UROSKOP D

Print No.: RLL5-310.076.04.01.02

Chapter 0 Revision

Replacement of the board, Part No. 11 11 256 by the board, Part No. 16 61 060.

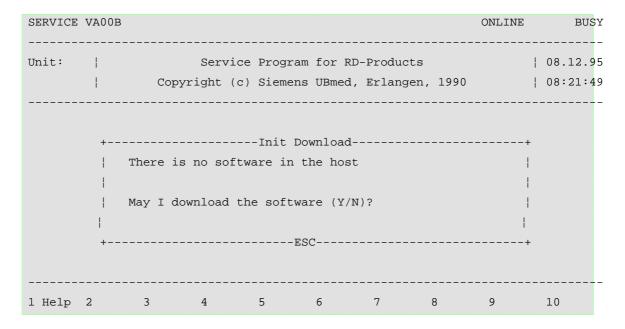
2.) Preparing the new host board for replacement:

- Solder the jumper X26 X27 on the new host board D1, Part No. 16 61 060.
- Remove the ICs J43 and J64 (these components are taken over from the old board).
- Remove the old host board D1, Part No. 11 11 256 from the control rack M20 and place it on a surface complying with the ESD regulations.
- Remove the ICs J43, J64 (PALs) and J66, J67 (Boot SW) from the old board and plug them onto the new board.
- Insert the new board, Part No. 16 61 060, in the control rack M20.
